DART AEROSPACE LTD	Work Order:	161193
Description: Crosstube Assembly, Mid Aft	Part Number:	D206-667-247
Inspection Dwg: D206-667-247 Rev: A		Page 1 of 2

DRAWING NO. D206-667-247	TITLE CROSSTUBE ASS'Y (206L MID AFT)	REV. A	DART AEROSPACE LTD ENGINEERING ORDER		D.E.O. NO. D206-667-247-A-1	SHEET NO. SHEET 1 OF 1	SCALE NTS
DRAWN <i>q</i>	CHECKED <i>ASS</i>	MFG. APPR. <i>KB</i>	APPROVED <i>JMP</i>		DE APPR. <i>#</i>		
DATE 11.07.15	DATE 11.07.20	DATE 11.07.21	DATE 11/07/21		DATE 11.07.21

PURPOSE:

REPLACE MAGNOBOND WITH PROSEAL.

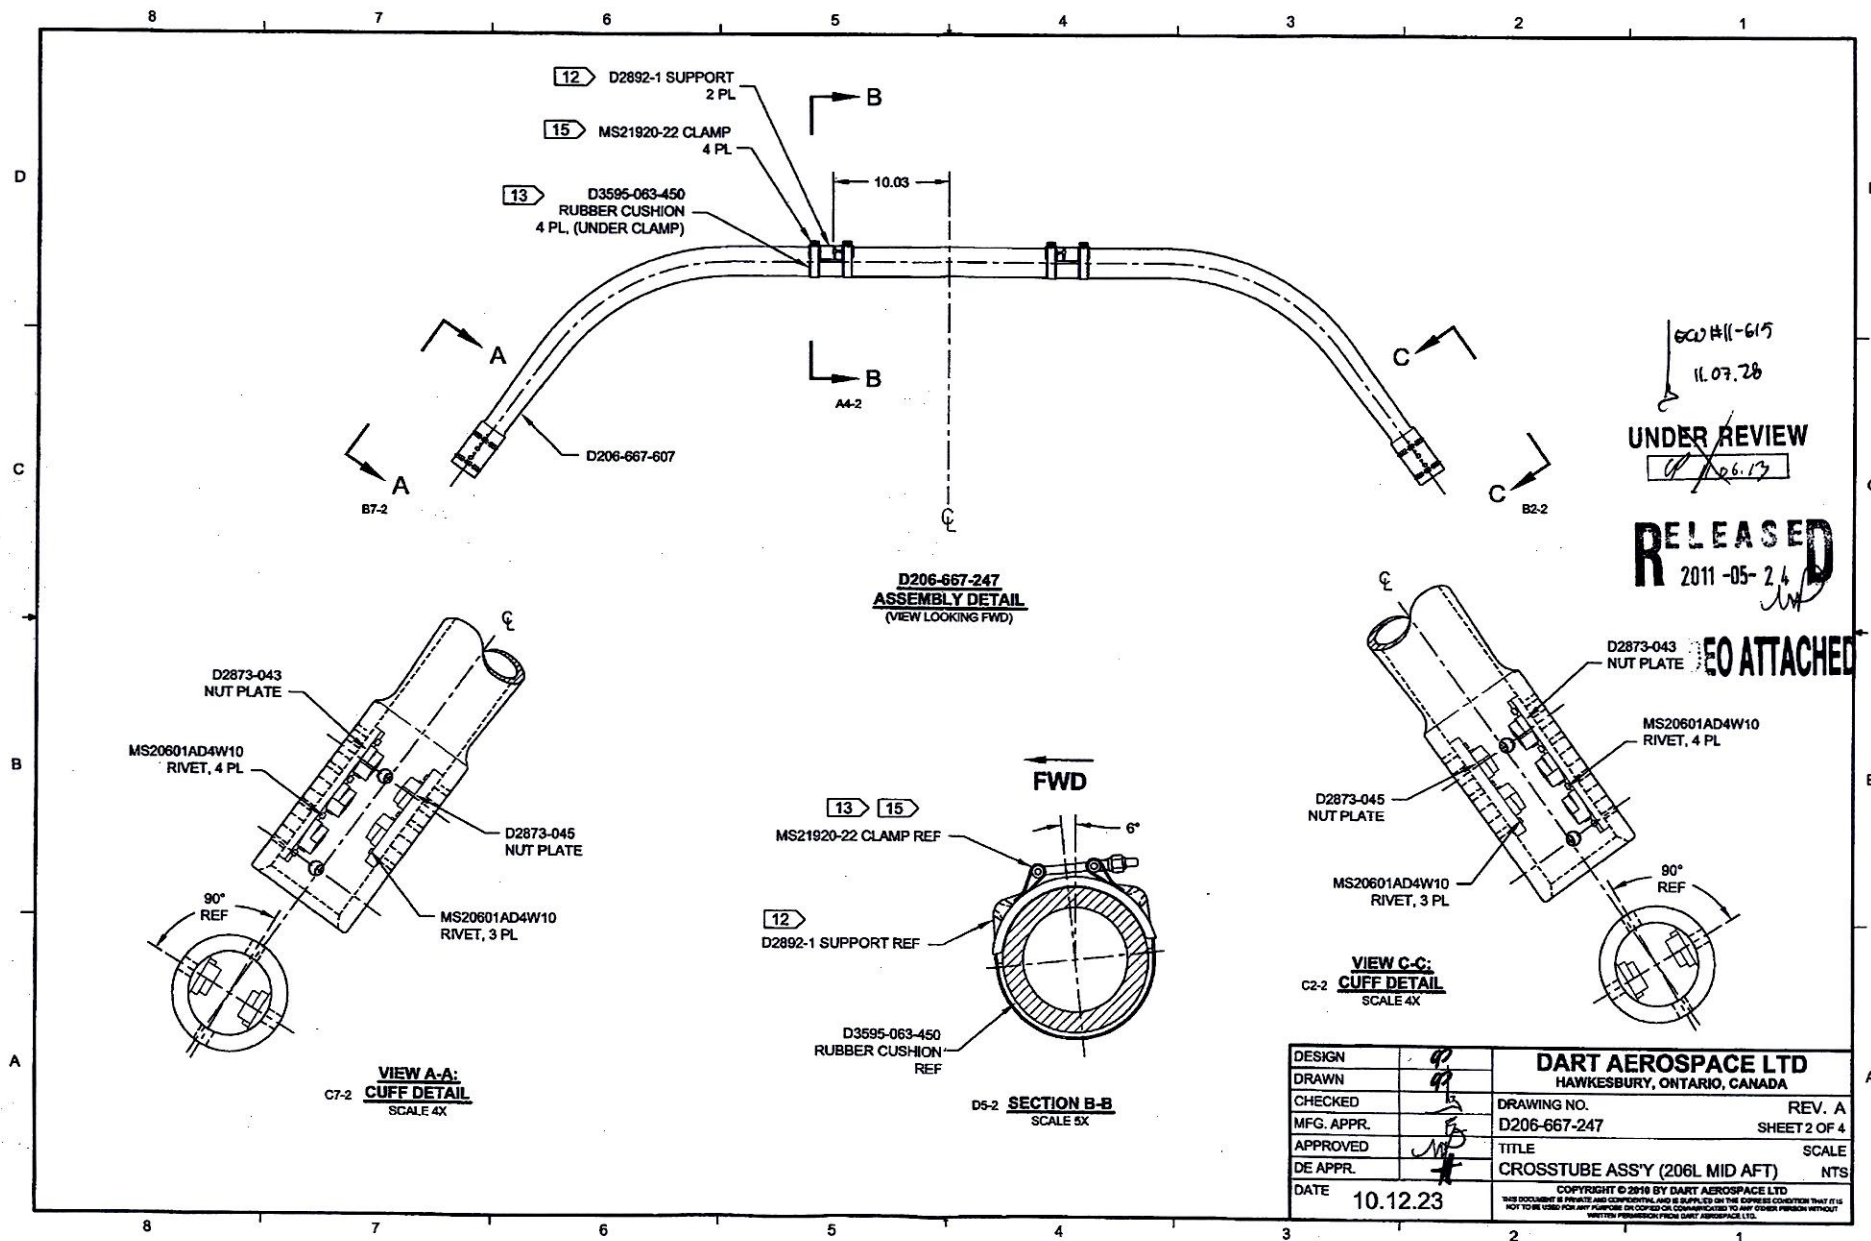
Item	Qty -247	Part Number	Description
9	A/R	PROSEAL 890 B-2	SEALANT, AMS-S-8802 CLASS B-2

9	A/R	MAGNOBOND 6398	ROCKWELL SPECIFICATION RBO-120-023 ADHESIVE (TEXTRON/BELL SPEC. 299-947-100, TYPE II, CLASS 2 ADHESIVE)
---	-----	----------------	---

NOTE 12 & 15, SHEET 1 IS AMENDED AS FOLLOWS:

- 12) INSTALL D2892-1 SUPPORT USING 0.03" TO 0.06" THICK LAYER OF MAGNOBOND 6398 PER QSI 015. LET CURE FOR 12 HOURS AFTER INSTALLATION AND PRIOR TO PACKAGING.
- 15) TORQUE CLAMPS 80 TO 100 IN-LB. ENSURE AT LEAST 1.5 THREADS SHOWING IN SAFETY AND THAT NUT HAS NOT BOTTOMED-OUT AFTER TORQUING.

- 12) TO INSTALL D2892-1 SUPPORT: ABRASE MATING SURFACE OF SUPPORT AND CROSSTUBE WITH 180-GRIT SANDPAPER AND REMOVE RESIDUE WITH MEK (OR EQUIVALENT). APPLY A 0.04" TO 0.07" THICK LAYER OF PROSEAL 890 CLASS B-2 (OR AMS-S-8802 CLASS B-2) SEALANT TO MATING SURFACE OF SUPPORT.
- 15) TORQUE CLAMPS 80 TO 100 IN-LB. ENSURE AT LEAST 1.5 THREADS SHOWING IN SAFETY AND THAT NUT HAS NOT BOTTOMED-OUT AFTER TORQUING. **PRIOR TO PACKAGING, RE-CHECK TORQUE ON CLAMPS AFTER PROSEAL 890 SEALANT HAS CURED FOR 72 HOURS.**
